SUBJECT: **REVISION "A" TO ALERT SERVICE BULLETIN 206L-04-129:
(FREEWHEEL AFT BEARING CAP 406-040-509-101, INSPECTION
AND REWORK OF)**

NO. 206L-04-129

SUBJECT: Freewheel aft bearing cap 406-040-509-101, inspection and recall of

Figure 1. Location of the lubrication channel and the serial number

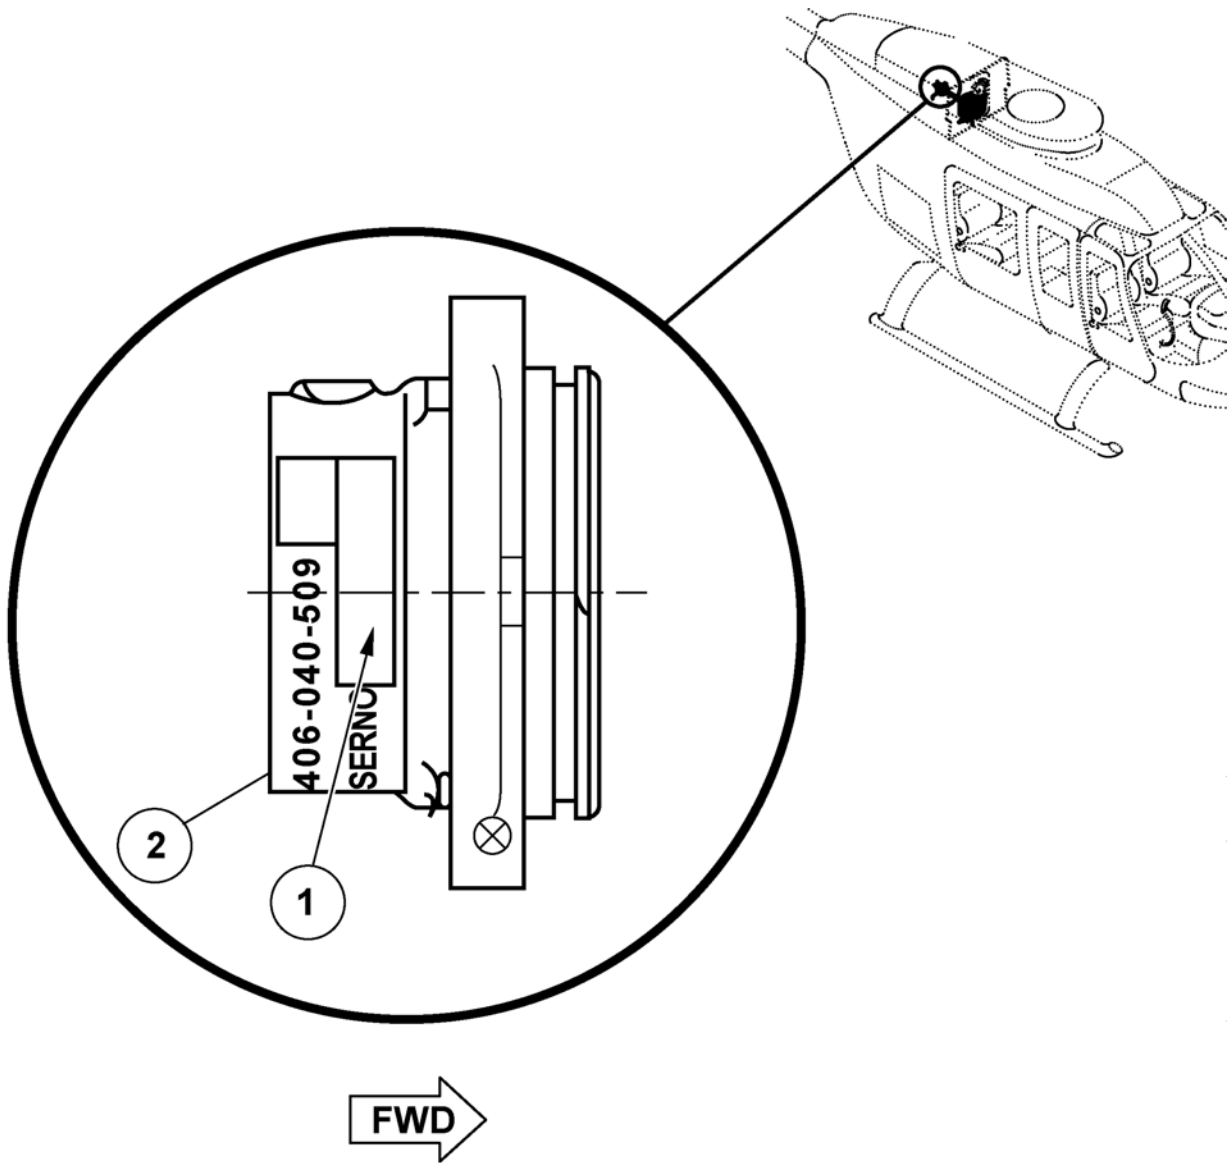
Bell Helicopter has found that some freewheel aft bearing caps are missing the lubrication channel intended to allow oil flow into the aft bearing support assembly. These caps may have been delivered on production aircraft or as spares.

1. Open the engine access doors.
2. Locate the serial number (1, Figure 1) of the freewheel aft bearing cap (2).
 - a. If the cap serial number is not listed in the HELICOPTER AFFECTED section, no further action is required. Close the access doors and continue with Step 3.
 - b. If the cap serial number is listed in HELICOPTER AFFECTED section, refer to the COMPLIANCE section and accomplish either PART II or III of this bulletin as directed. Contact Product Support Engineering Light Helicopters with the P/N, S/N, TSN, and TSO of the aft bearing cap and freewheel assembly:

Figure 2. Parts affected by the missing lubrication channel

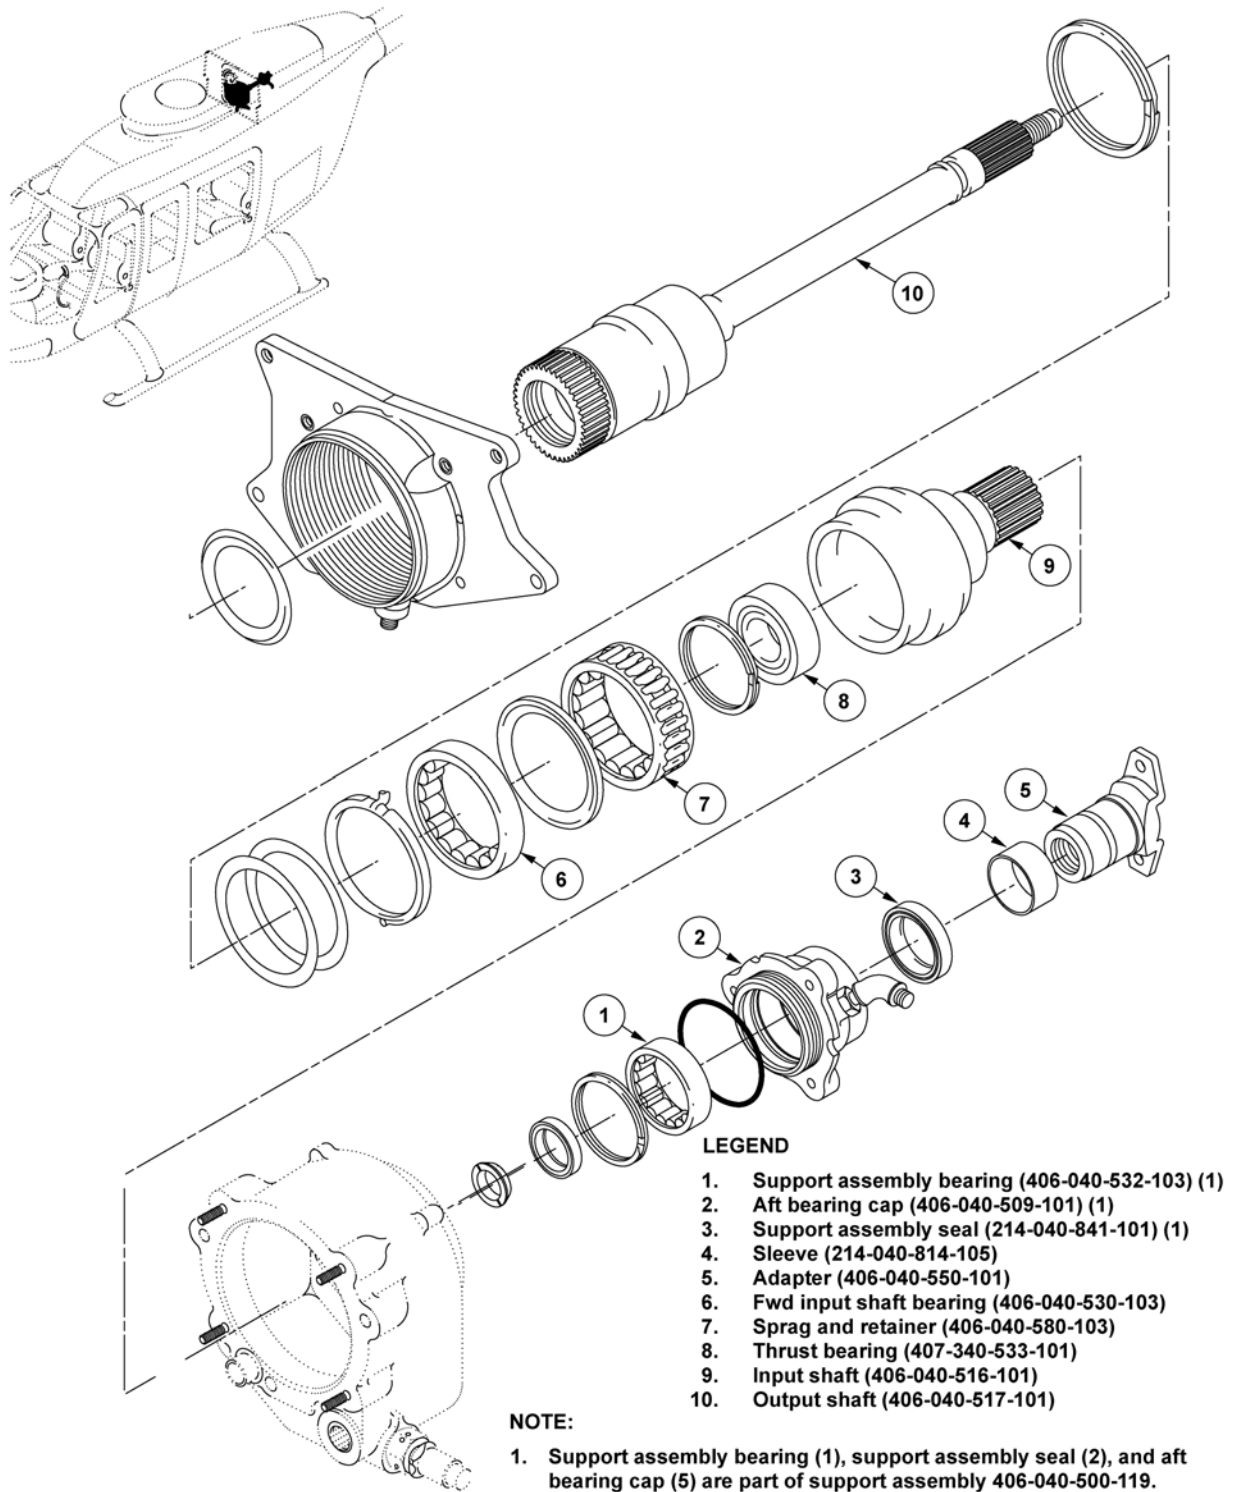
1. Remove the engine cowling and transmission fairing assembly (BHT-206L4-MM, Chapter 53).
2. Remove the forward short shaft (BHT-206L4-MM, Chapter 65).
3. Remove the aft adapter (5, Figure 2) and aft bearing cap (2) (BHT-206L4-MM, Chapter 63).

4. Remove bearing (1) from the aft bearing cap (2) (BHT-206L4-MM, Chapter 63).
5. Remove and discard the support assembly seal (3).
6. Inspect support assembly bearing (1) for condition (BHT-206L-CR&O). Replace bearing if defective.

2. Disassemble the freewheel assembly (BHT-206L-CR&O, Chapter 63).
3. Discard the sprag and retainer (7, Figure 2), the output shaft (10), and the aft seal (3).
4. Visually inspect the remaining freewheel part details for condition (BHT-206L-CR&O, Chapter 63).
5. Select from the following list, the rework option deemed most suitable for convenience:

Bell Helicopter Tennessee Textron
157 Industrial Park Road
Piney Flats, TN. 37686
Office: 423-538-5114
Fax: 423-538-6198.
9. Install the support assembly bearing (1) and seal (3) into the aft bearing cap (2) (BHT-206L4-MM, Chapter 63).
10. Install the aft bearing cap (2) and adapter (5) (BHT-206L4-MM, Chapter 63).
11. Install the forward short shaft (BHT-206L4-MM, Chapter 65).

- A
- a. If the freewheel assembly is currently located in spare stock, continue with step 3.
 - b. If the freewheel assembly has had PART II of this bulletin complied with, continue with step 2.
 - c. If the freewheel assembly has had PART III of this bulletin complied with, continue with step 8.
2. Remove freewheel assembly (BHT-206L4-MM-6, Chapter 63).
 3. Disassemble the freewheel assembly (BHT-206L-CR&O, Chapter 63).
 4. Discard the sprag and retainer (7, Figure 2) and the output shaft (10).
 5. Visually inspect the remaining freewheel part details for condition (BHT-206L-CR&O, Chapter 63).
 6. Assemble the freewheel assembly (BHT-206L-CR&O, Chapter 63).
 7. Install the freewheel assembly (BHT-206L4-MM-6, Chapter 63).
 8. Make an entry in the helicopter Technical Records to show that PART IV of the Alert Service Bulletin has been completed.

Figure 3. Instructions required to modify the aft bearing cap 406-040-509-101

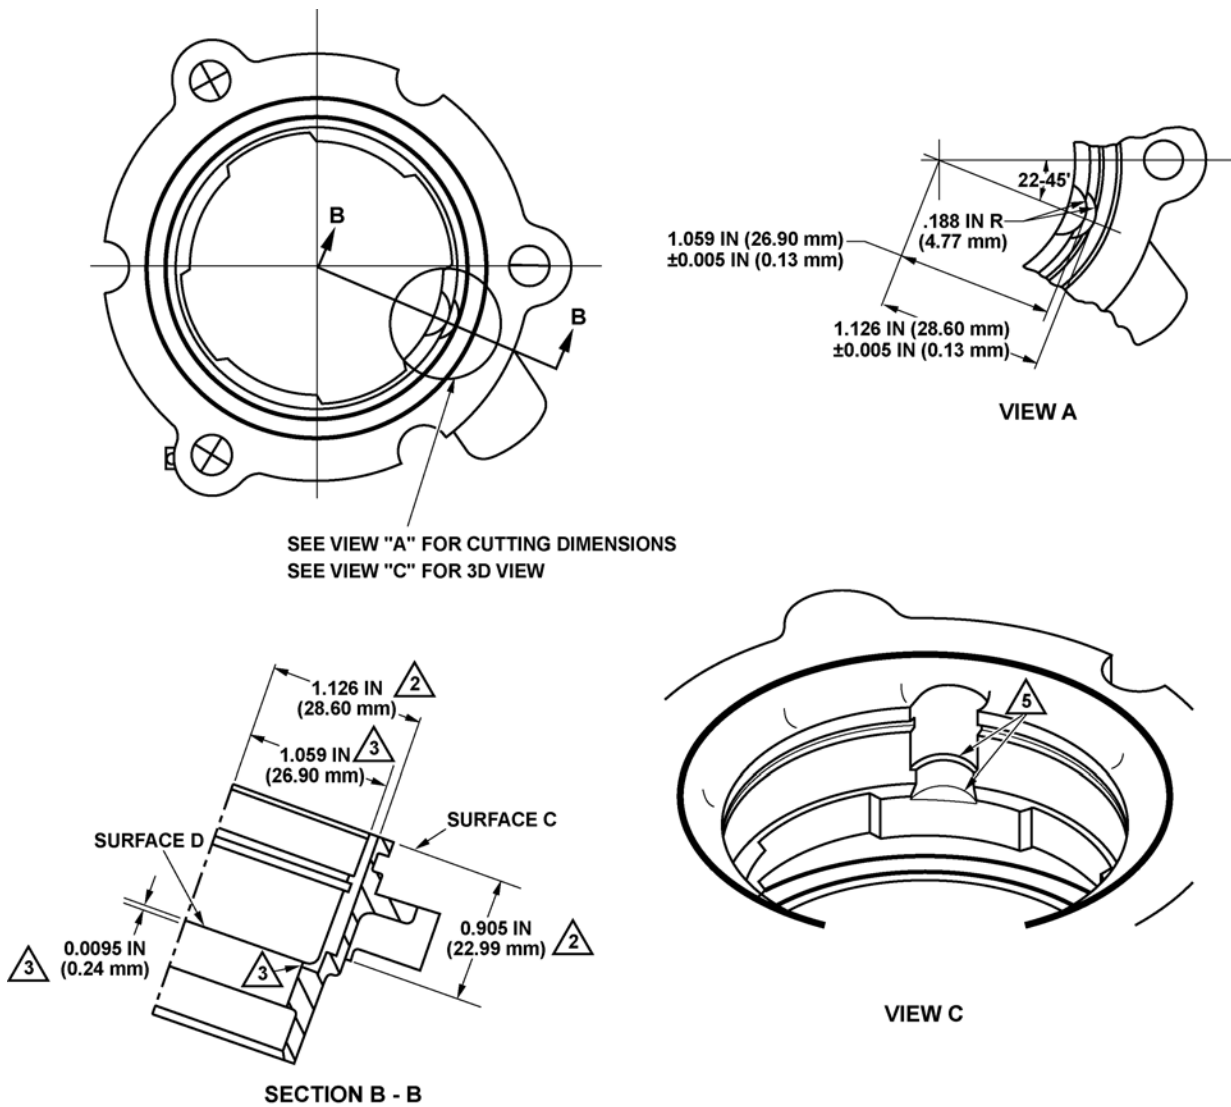
- b. Locally rework the aft bearing cap as shown in Figure 3. Use a vibrating stylus to identify locally-reworked cap assembly by adding letter "R" to the serial number on the cap.

- b. Locally rework the aft bearing cap as shown in Figure 3. Use a vibrating stylus to identify locally-reworked cap assembly by adding letter "R" to the serial number on the cap.

1. Surface finish to be 125 u inch RMS
2. Machine scallop 1.126 inch (28.60 mm) ±0.005 inch (0.13 mm) into bore. Length of scallop to be 0.905 inch (22.99 mm) ±0.010 inch (0.254 mm) from the surface C.
3. Machine scallop 1.059 inch (26.90 mm) ±0.005 inch (0.13 mm) into bore. Scallop to be 0.0095 inch (0.24 mm) ±0.0025 inch (0.06 mm) below surface D.
4. Break all sharp edges.
5. Machine scallop radius .020 inch maximum 2 places
